YARBROUGH DRIVE MASTER PLAN

9 July 2013

NCSU Project: 200820026

Project Number: 2008 20026
Project Name: Yarbrough Drive Master Plan
Project Manager: Bill Davis
Design Phase: Planning Study
Discipline:
Consultant: O'Brien Atkins
Reviewed by: Bill Davis

Figure 1: Project Study Area

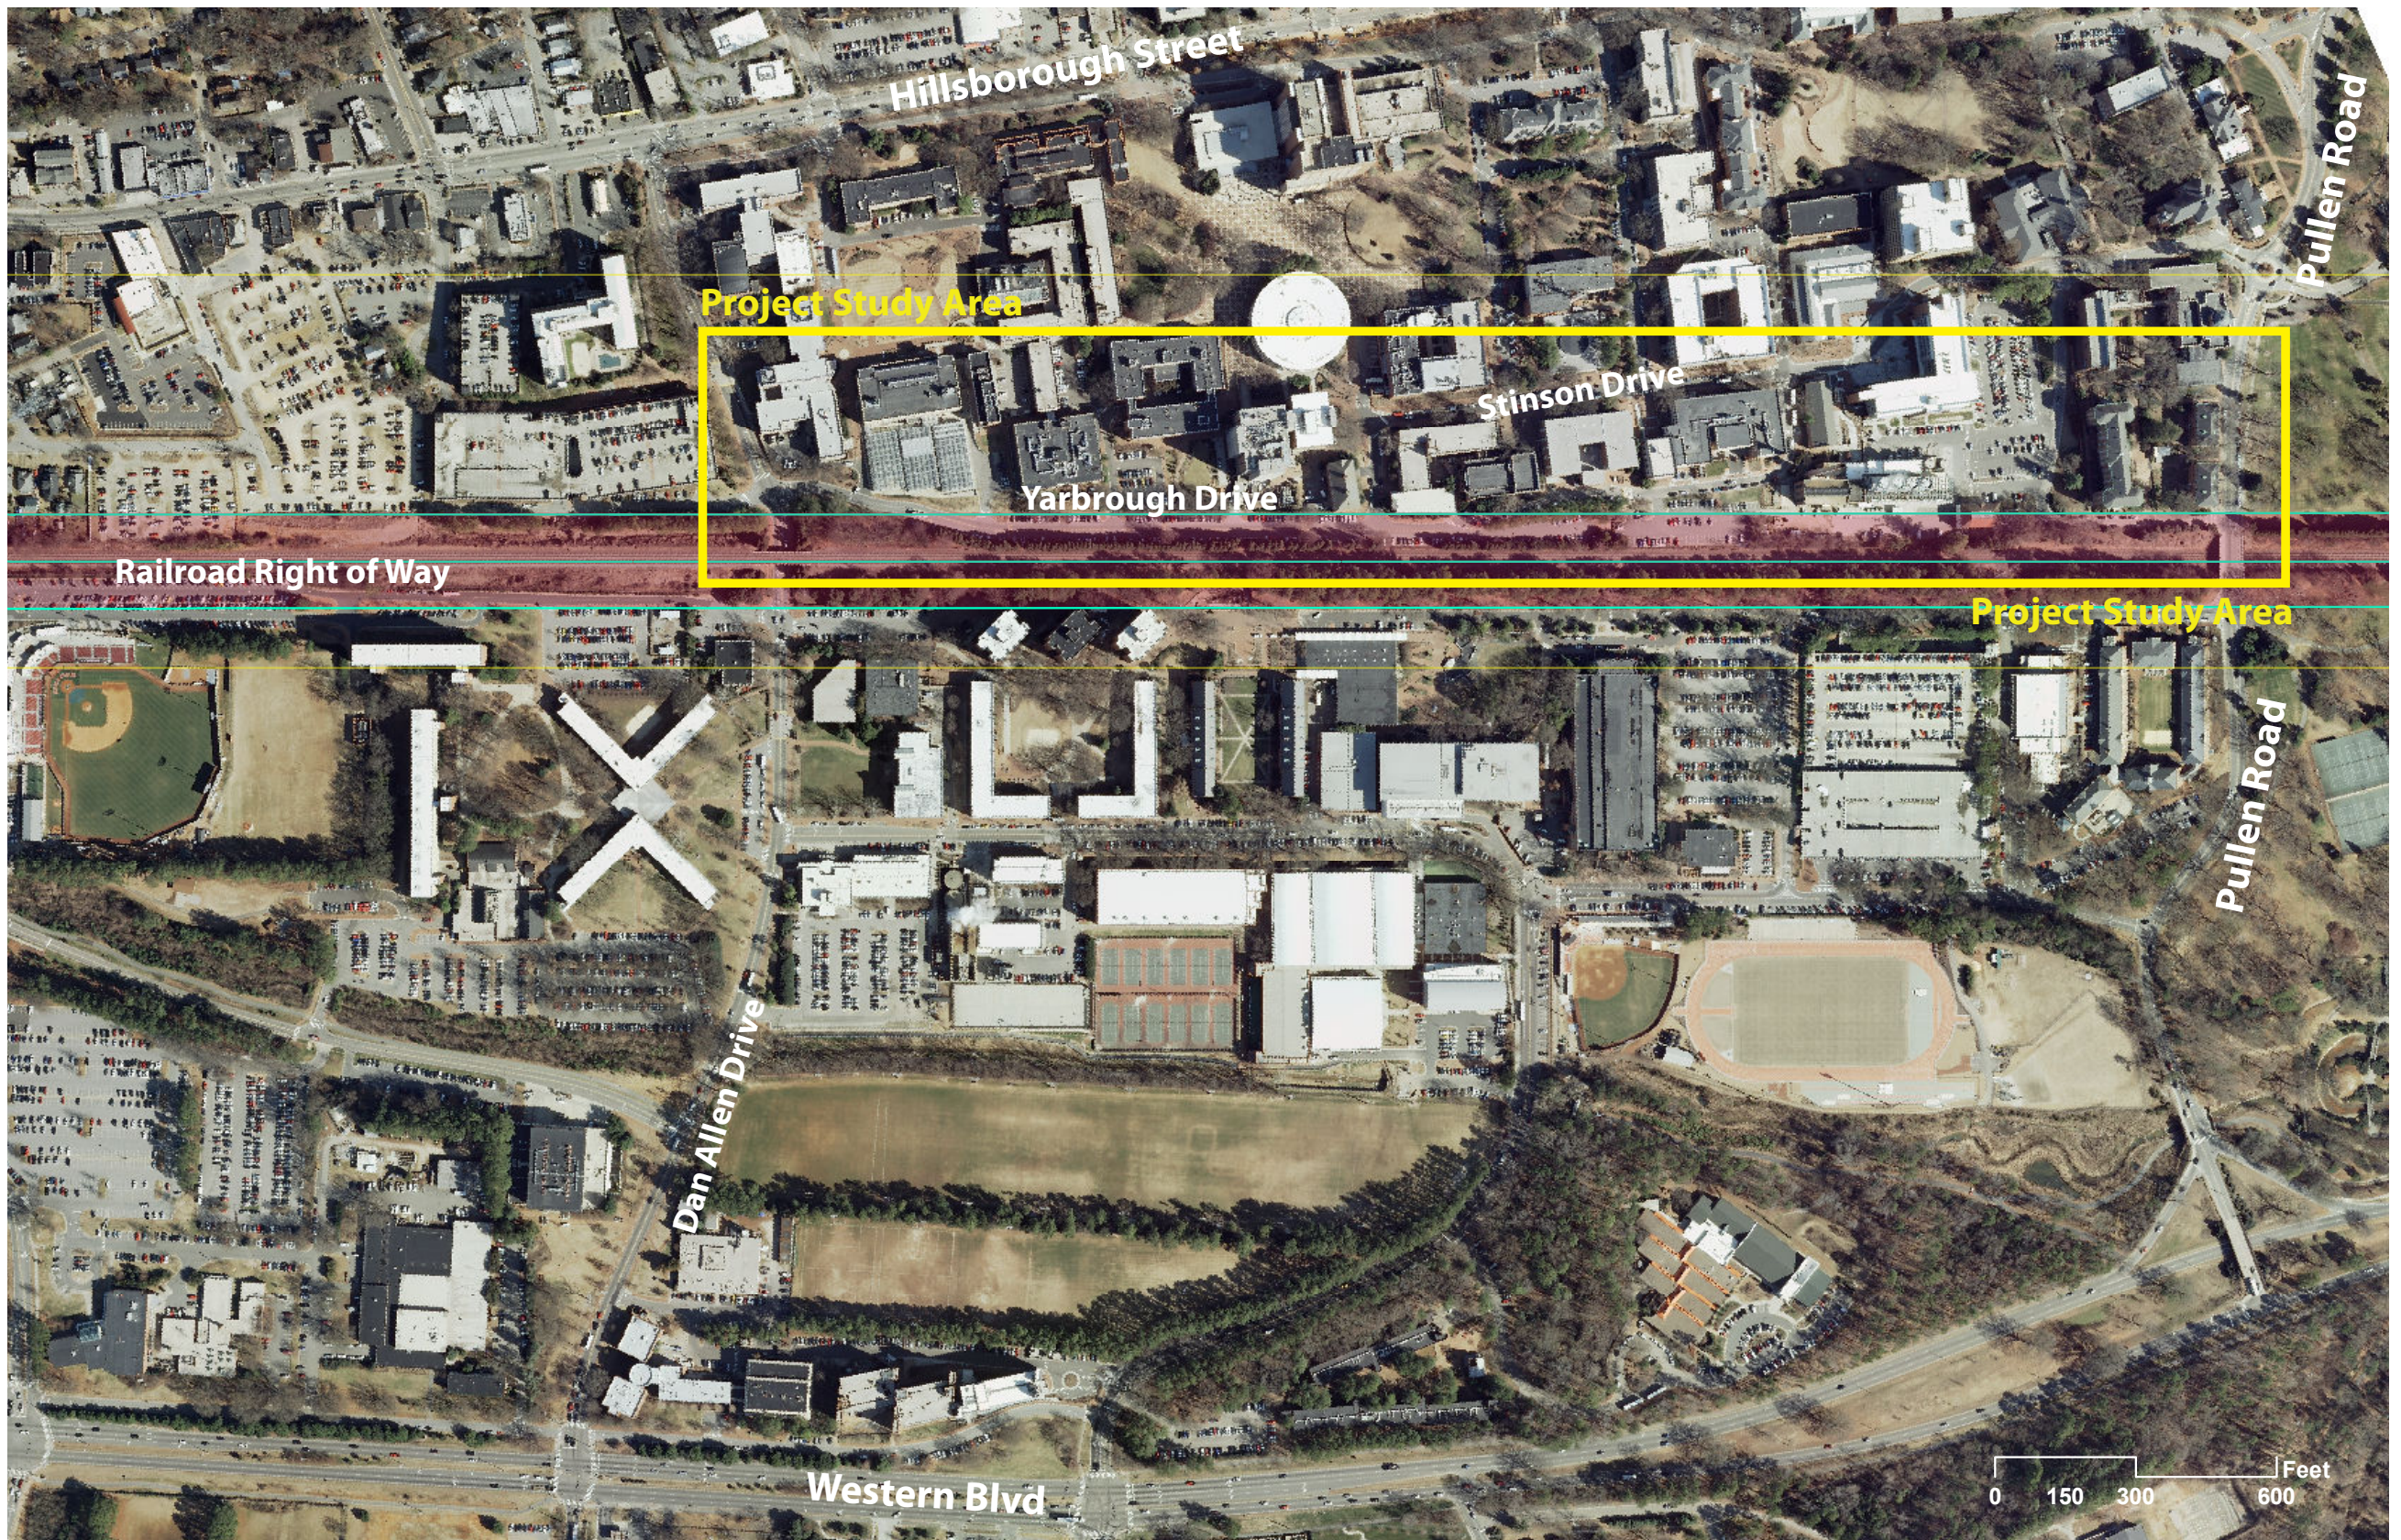
1. Page 5: Provide more context to the view area. The page should allow from Hillsboro to Western. Add general labels	1. Will comply
2. Existing parking and proposed parking needs to be addressed, with quantities of different types of parking identified (service, staff, residential, etc.).	2. On Nov 27, 2012 we rec'd parking info we had requested – NCSU reported to us that 379 spaces exist in the study area. No breakdown of spaces was given. A parking study was not part of our scope of services. We will note the 379 spaces in the study area – and the number of spaces impacted by the recommendations.

Figure 2: Diagram of existing vehicular circulation

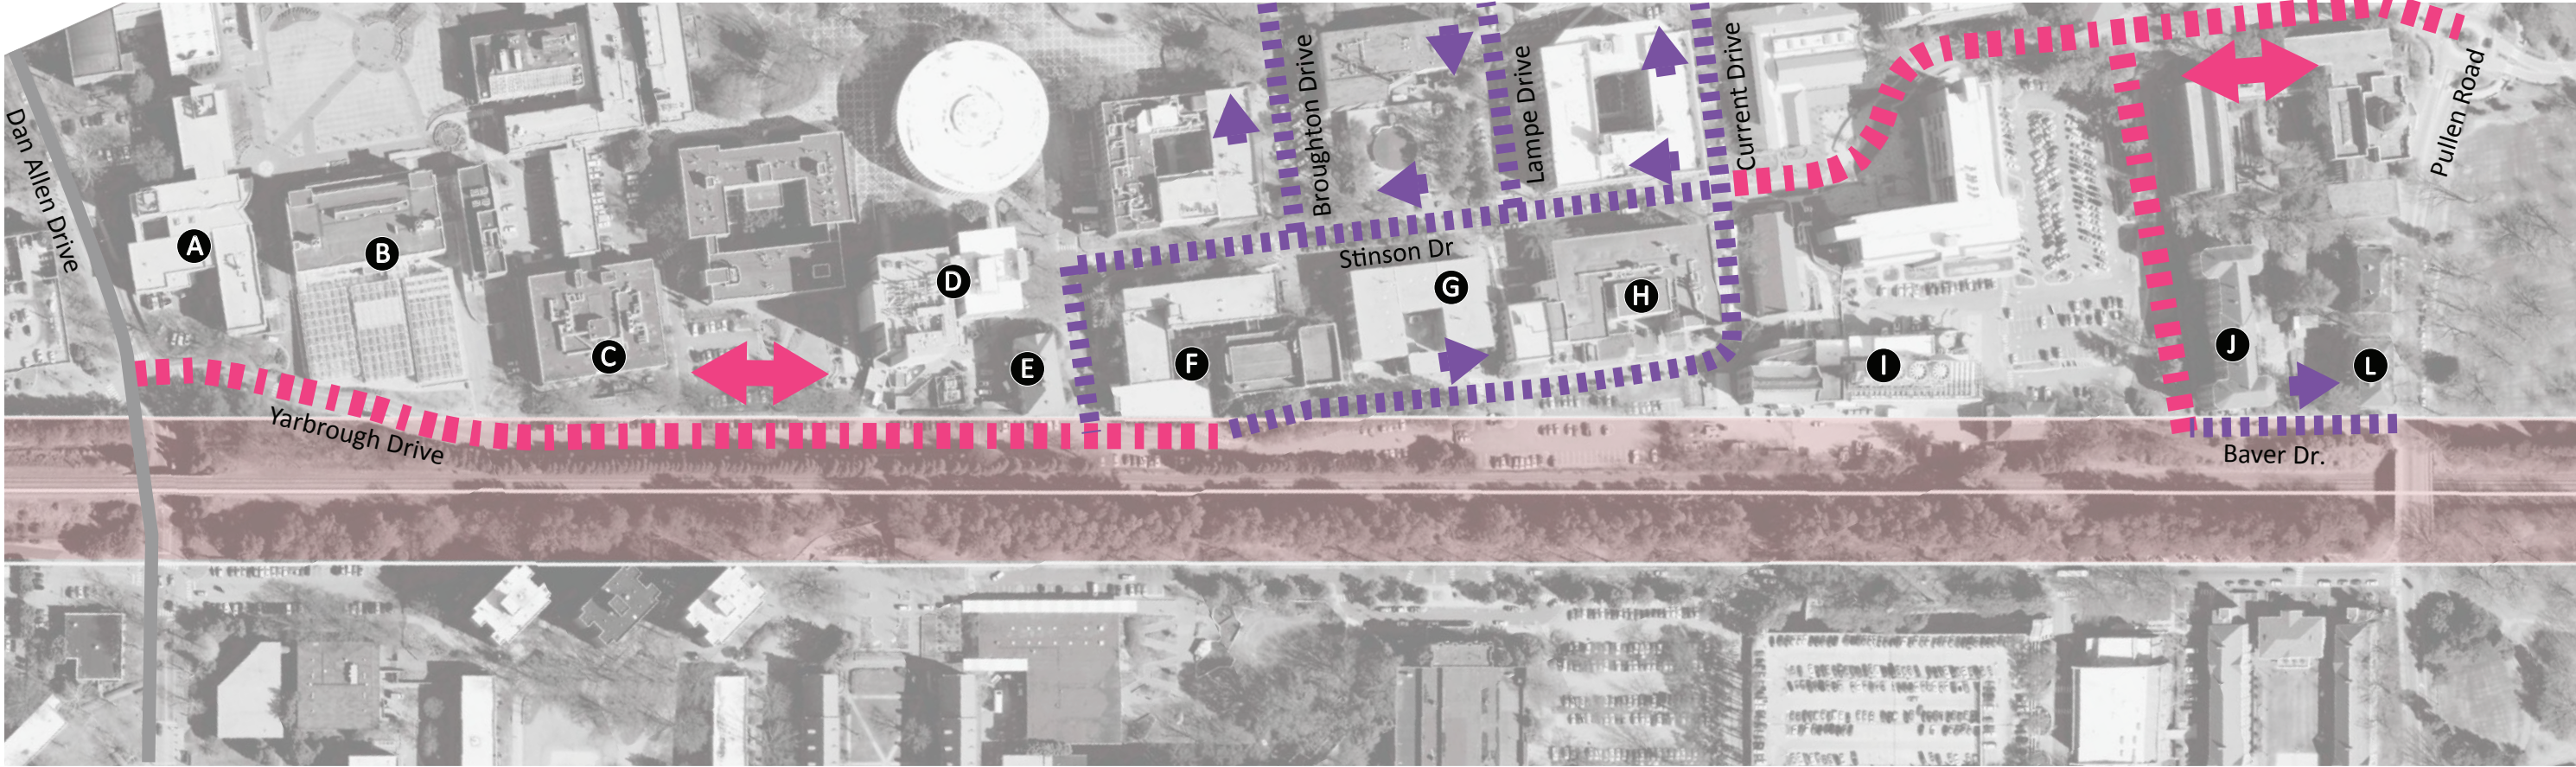
11. On page 7, the legend transposes labels for one-way and two-way circulations.	11. We will correct this
12. On page 8, Dan Allen is closed "9"am until 5pm, not 8am until 5pm.	12. We will make this edit

Figure 10: Existing sections key map

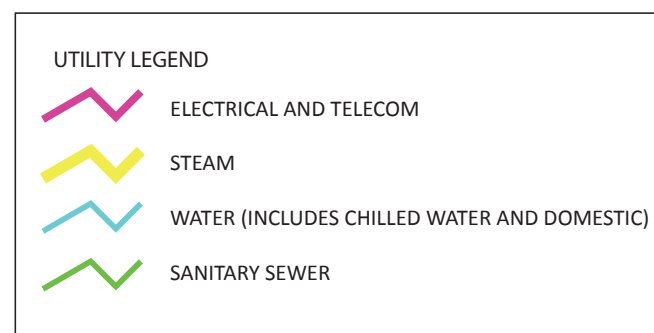
5. Page 25: Box under plinth looks like it might be the steam tunnel – label as such or remove. Page 24 shows the retaining wall and rail. Is the ewall/rail missing at this location.	5. This is the steam tunnel and has been labeled as such. Rail added

Figure 31: Area B1 cost opinion reference plan

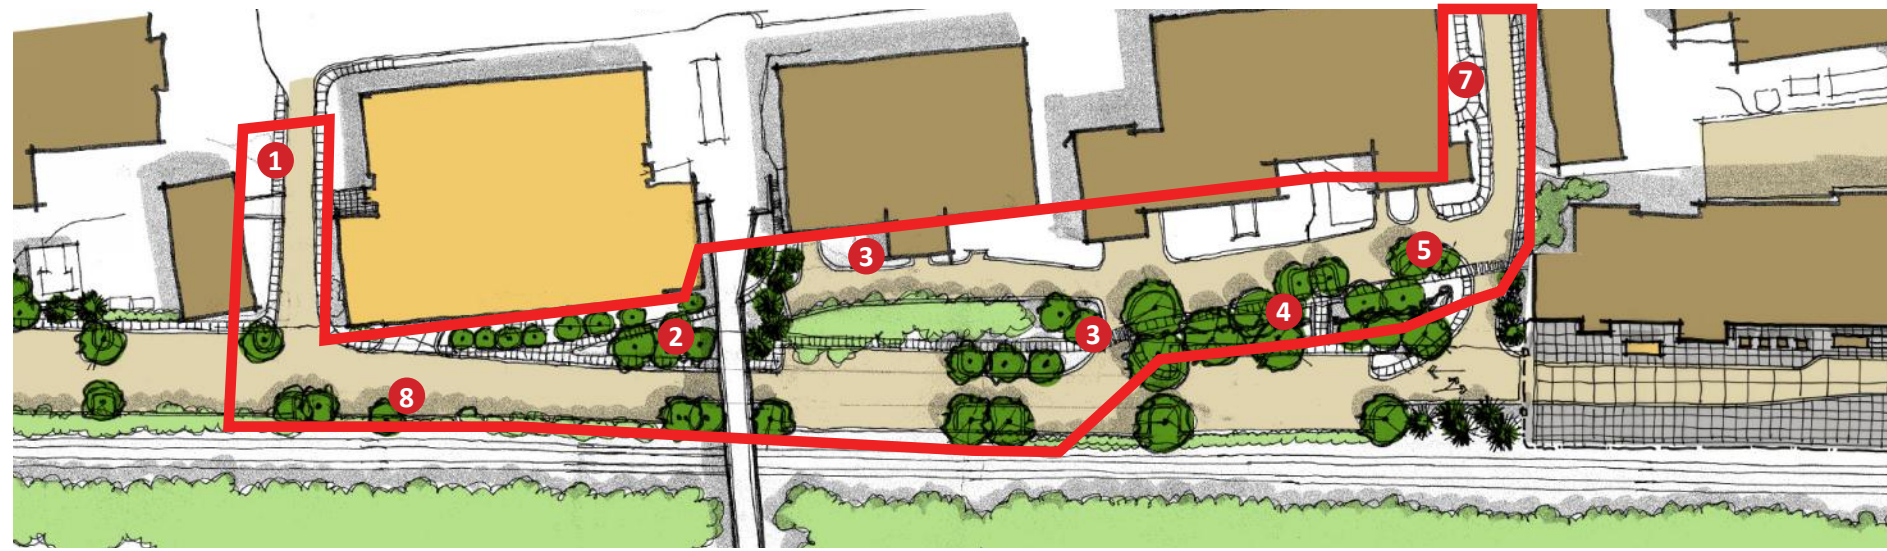
32. p.41 – Figure 31 appears to be mislabeled; should be Area C, not Area B.	32. We will edit
